UNITED STATES PATENT AND TRADEMARK OFFICE

Office Action Summary	Application No. 10/065,489	Applicant(s) RAND, ROY EDWARD	
	Examiner Phillip A Johnston	Art Unit 2881

Detailed Action

FIG.-3

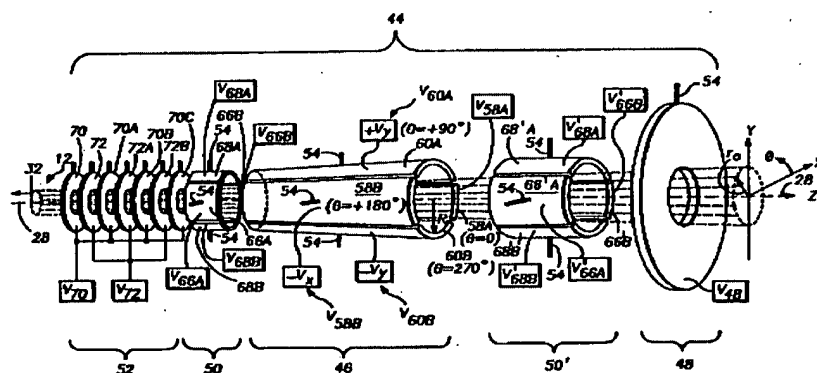
And Figure 3 in 5,193,105, attached below;

The examiner has interpreted from the Rand (445) references above that a grounded tube 50' and an ion trapping region 46 are used in the downstream region to allow ions to accumulate therein, as recited in claims 1,7,17, and 19.
